Enstrom Maintenance Alert

12/19/14

4129104-() Oil Cooler Bearing Support.

Enstrom 480B, 1400 hrs

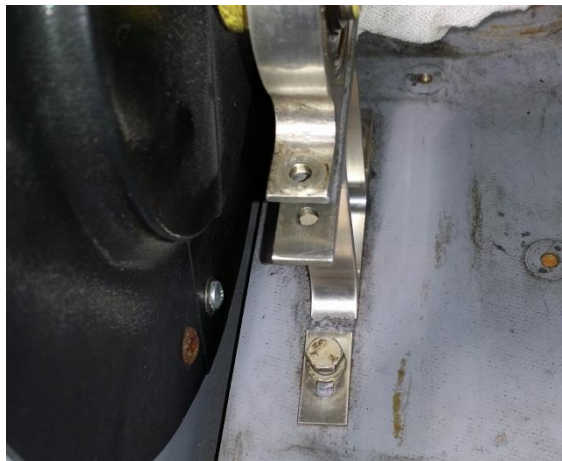
It was reported that a technician found a cracked oil cooler blower bearing support bracket. He was having trouble aligning the blower short shaft. This support bracket was replaced by a 4129104-19 bracket which has a thicker bottom flange.

Enstrom recommends occasional cleaning of the fan squirrel cage fan to prevent out of balance, and installation of the -19 support bracket.
